SUBJECT: Calvert Cliffs Nuclear Power Plant
Unit Nos. 1 & 2; Docket Nos. 50-317 & 50-318
Response to Request for Additional Information – License Amendment for
Measurement Uncertainty Recapture Power Uprate - Calvert Cliffs Nuclear
Power Plant, Unit Nos. 1 and 2

**RESPONSE TO REQUEST FOR ADDITIONAL INFORMATION
(ML090770532) - MEASUREMENT UNCERTAINTY RECAPTURE
POWER UPRATE**

Figure 12- Schematic drawing showing flow phenomena in a curved duct.

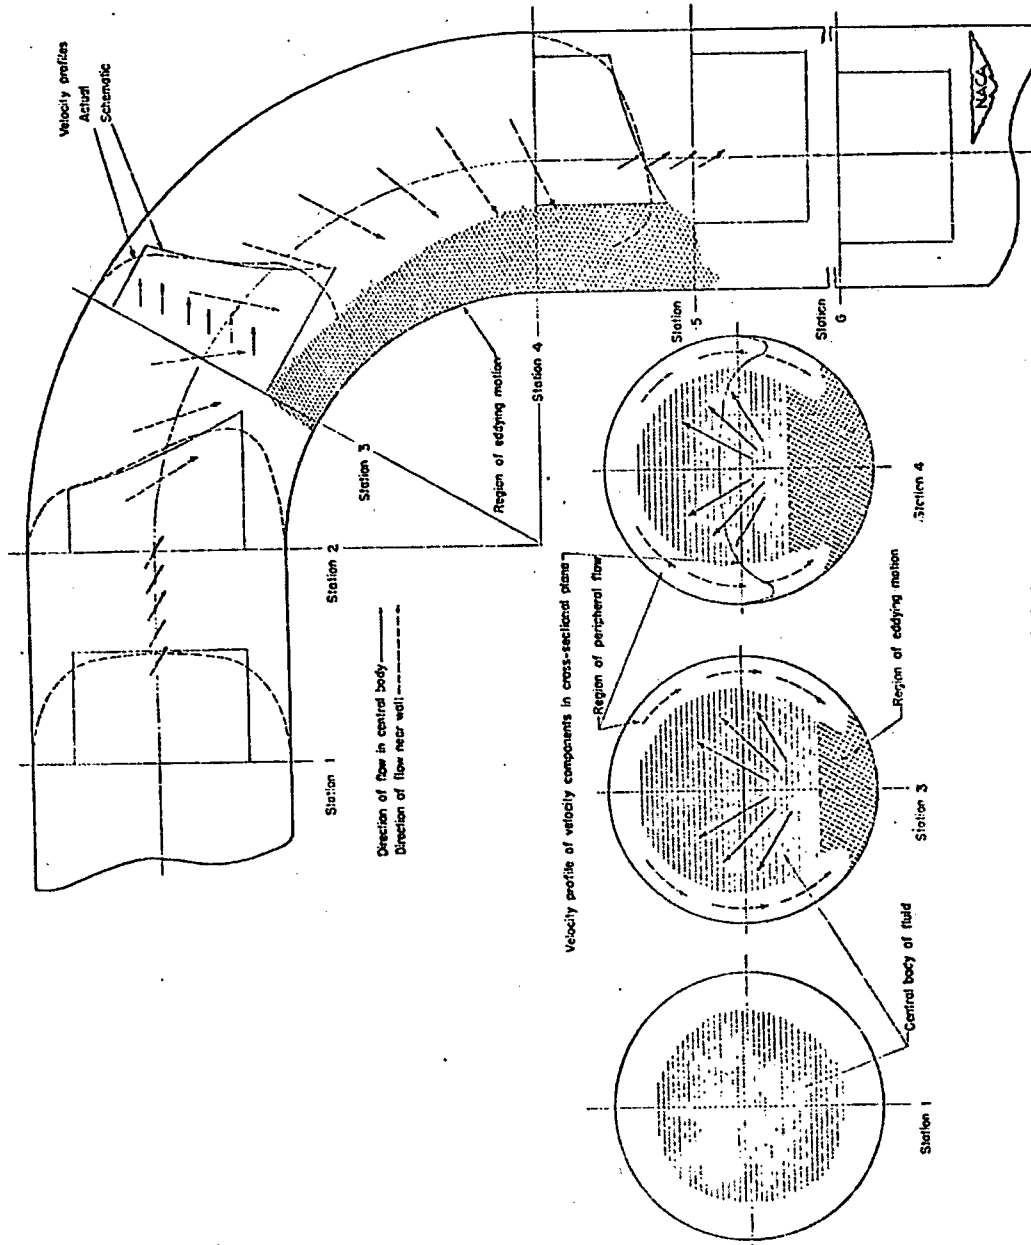
The information provided by the licensee shows inconsistencies between the laboratory calibration setup and the piping run in that there are nearby elbows downstream of the in-situ ultrasonic flow meter installation. The supplement does not appear to discuss or explain these differences between the as-tested and as-installed configuration, as requested by the staff.

This is particularly of concern for the Unit 1, Loop A header, where the spool piece is to be installed 1 foot, 3 inches upstream of a piping elbow. This is narrowly less than a single piping diameter, and far less than the 20 or greater pipe diameters commonly accepted to be the required length to establish fully developed, turbulent flow.

Please explain how the laboratory calibration accounts for the close-by downstream configuration changes that are not displayed in the laboratory testing report.

A downstream disturbance such as a bend can produce changes in the direction of local fluid velocity components upstream, but not at distances greater than 1 internal diameter from the entrance to the

disturbance. The chordal paths of the Leading Edge Flow Measurement (LEFM) CheckPlus in Loop A of Unit 1 at Calvert Cliffs are 2.7 diameters upstream of the entrance to the bend.

- In Figure 12 of his technical note No. 1471, Weske² shows that at station 1, one diameter upstream of the entrance to the bend, the profile is fully developed and symmetrical, with no transverse velocity components. A copy of the figure is attached for convenience.
